ADDENDUM NO. 2-R

CITY BID NUMBER: 274-ES-FO-FY24-KEETERRENOVATIONS – R (REBID)

Project: Keeter Training Center - Renovations

Architect: Redline Design Group, PA

E111

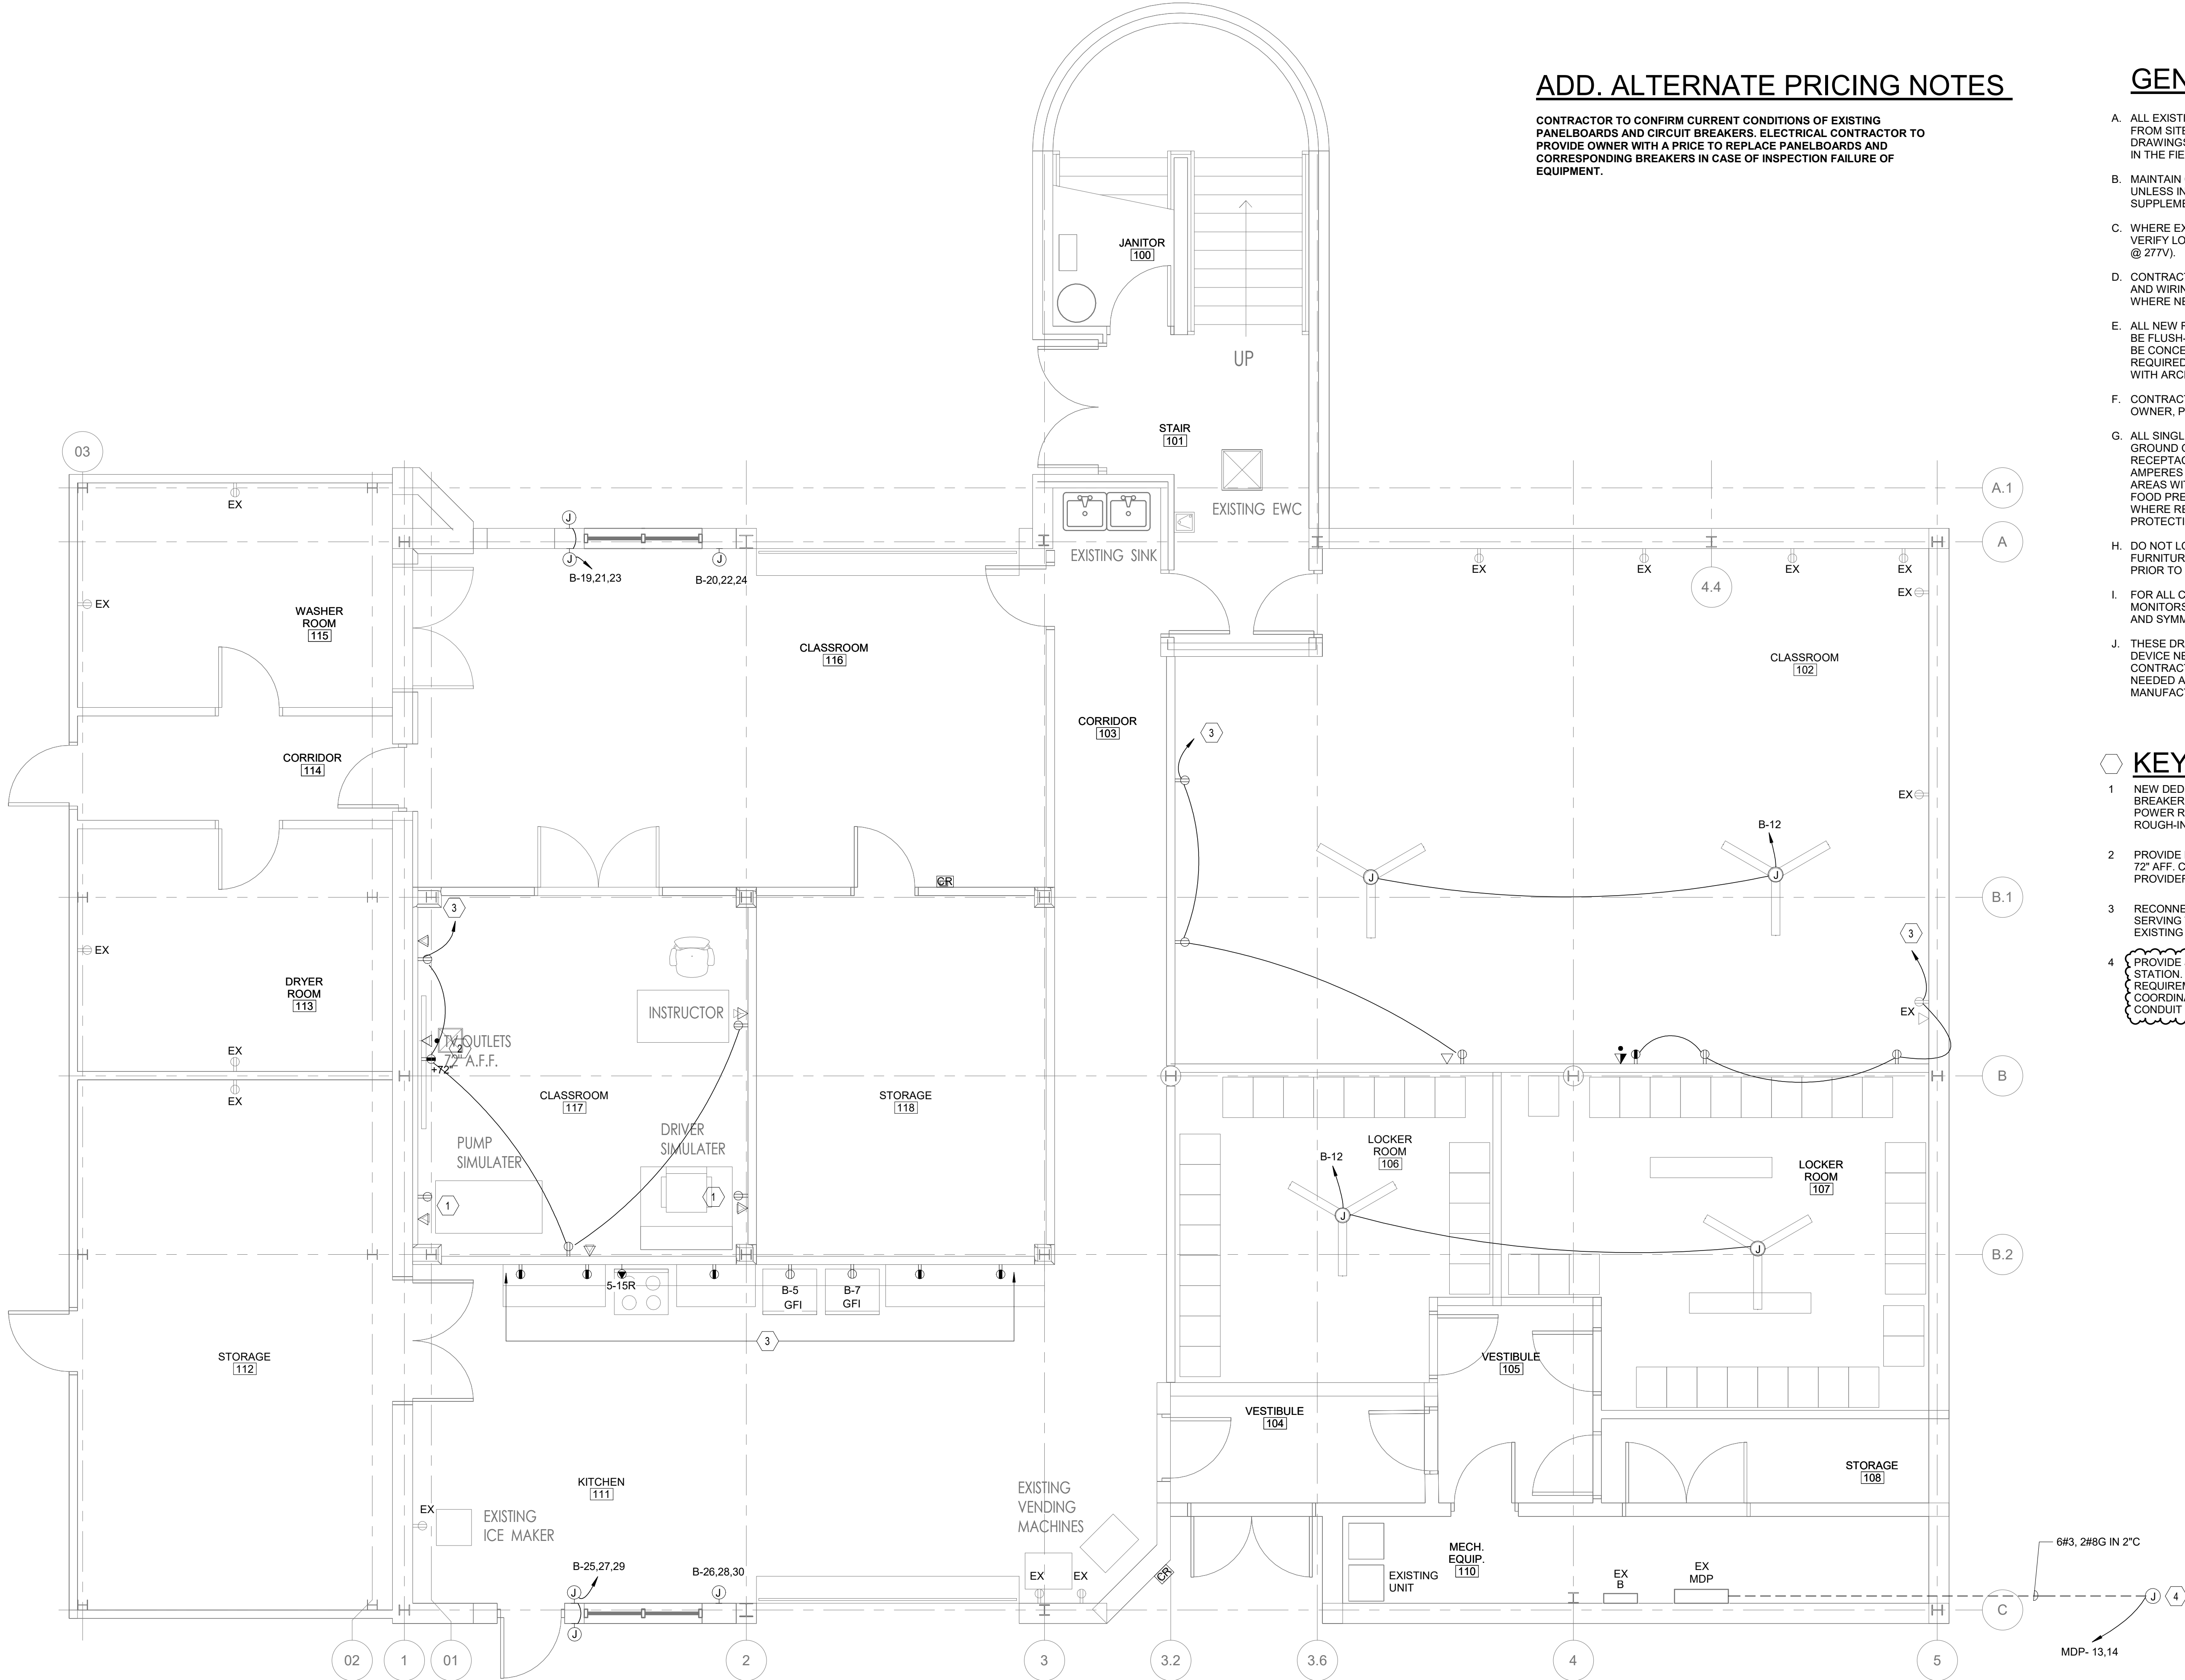
REVISE the note referencing the car charger conduit to read as follows: "GC shall trench underground and provide conduit with sealed penetration through existing brick/cmu wall on east side of building where shown on electrical drawing E111. Car charger shall be connected to circuit in MPD panel in Elec. Room 109 as shown on sheet E700."

21. Electrical Drawings E111, E121, E122, E123 and E500 :
REPLACE previously issued sheets with attached revised sheets E111, E121, E122, E123 and E500 noted with Revision 1. See sheet E500 for updates to light fixture model numbers."
